**STATE OF DELAWARE
EXECUTIVE DEPARTMENT
OFFICE OF STATE PLANNING COORDINATION**

RE: PLUS review – 2013-02-01; Rockwood Parcel 1-A

Thank you for meeting with State agency planners on February 27, 2013 to discuss the proposed plans for the Rockwood Parcel 1-A located on Rockwood Road and Pulaski Highway in New Castle County.

According to the information received, you are seeking site plan approval through New Castle County for 438 apartments on 37 acres.

New Castle County PLUS 2013-02-01 Rockwood Parcel 1-A

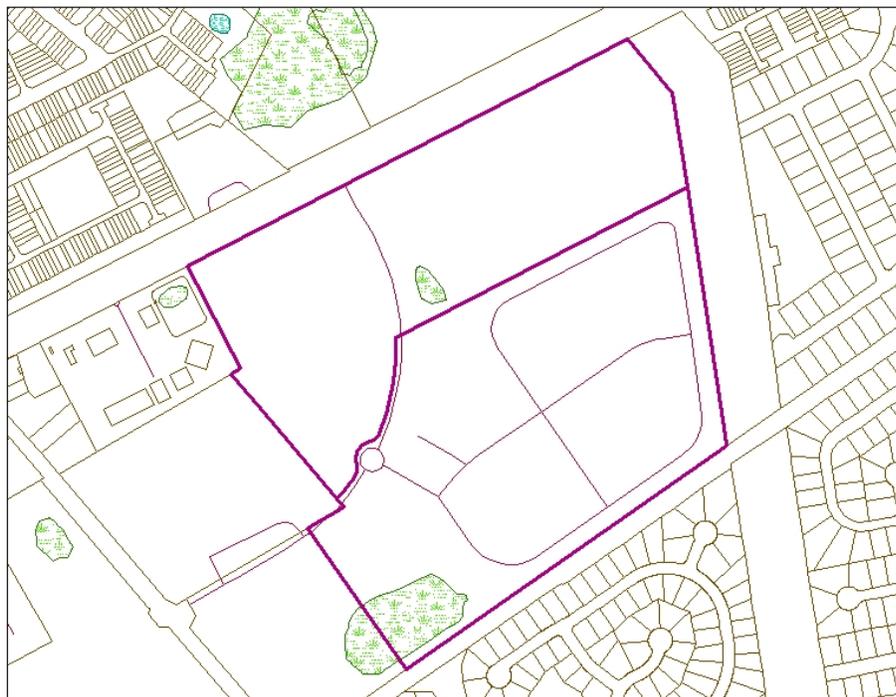
- State regulated wetlands ARE NOT located on this property based on a review of the State wetland maps.
- State regulated subaqueous lands ARE NOT likely to be located on this property based on a review of aerial photographs, SWMP maps, Soil Surveys and USGS topographic maps.
- Waters of the U.S. regulated by the U.S. Army Corps of Engineers ARE possible on the edge of this property based on a review of aerial photographs, SWMP maps, Soil Surveys and/or USGS topographic maps. According to our GIS SWMP maps, there are possible wetlands regulated by the U.S. Army Corps of Engineers. We suggest contacting them for an on-site inspection.

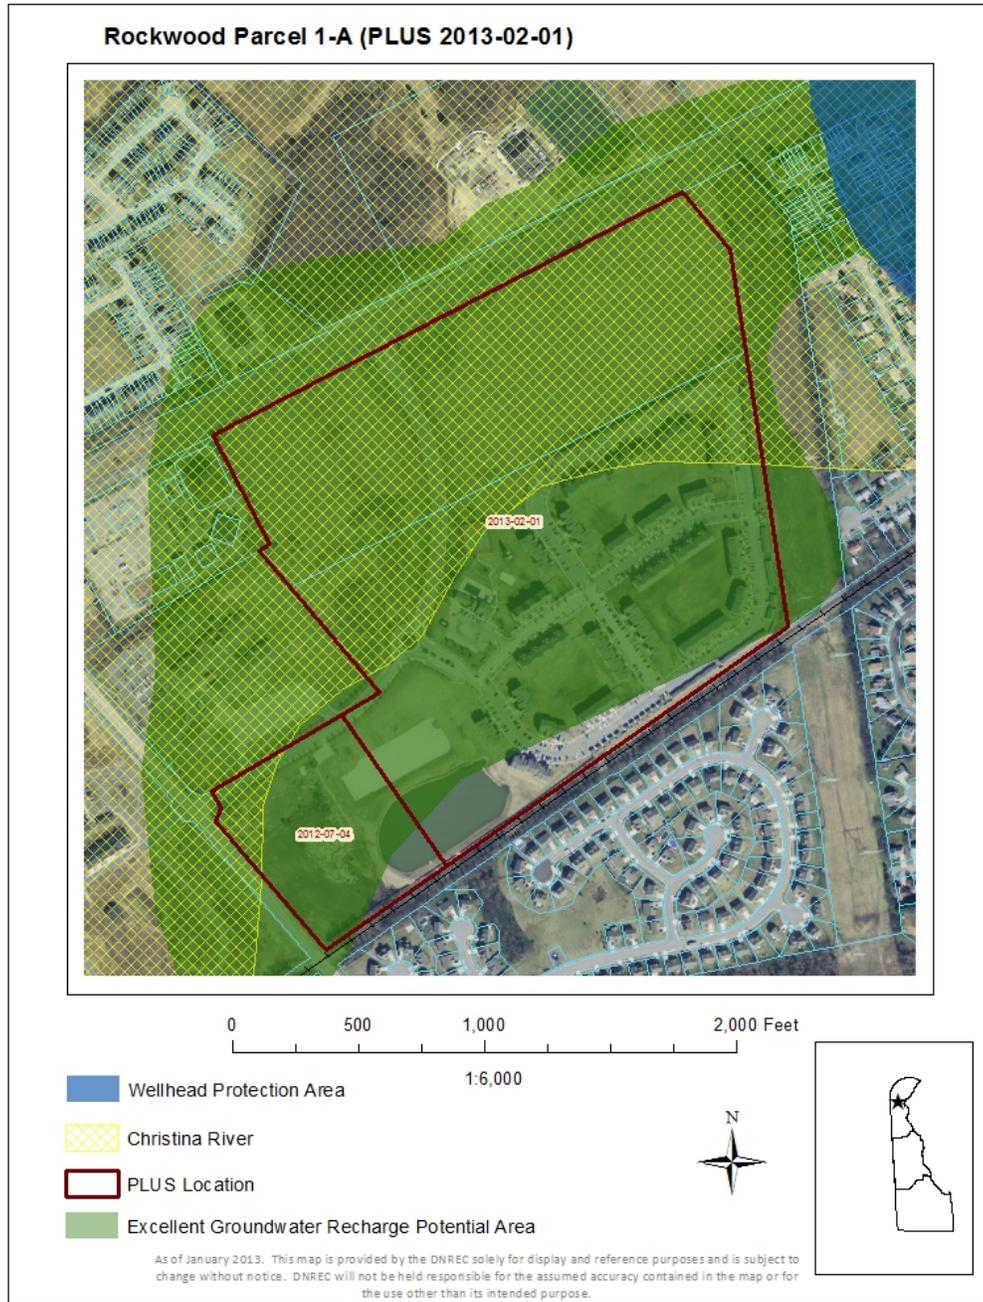
- Based on soils survey mapping update, following soil mapping units were mapped on subject parcel (grouped on the basis of drainage class; see figure 1):

- 1) Well drained – Greenwich (GrB) & Unicorn (UIA)
 - 2) Moderately well drained –Woodstown (WdA)
 - 3) Variable drainage – Ingleside-Hammonton-Fallsington complex(ImB); though listed as well drained in map, this soil mapping unit is likely to contain well-drained, moderately well drained & poorly drained (hydric) soil mapping components in same map unit.

- Based on apparent soil variability, DNREC strongly recommends a certified and licensed soil scientist (ARCPACs certified and Class D licensed) make a site-specific evaluation of the soils in this parcel. Please contact the Underground Discharges Branch at 739-9948 for a list of soil scientists.
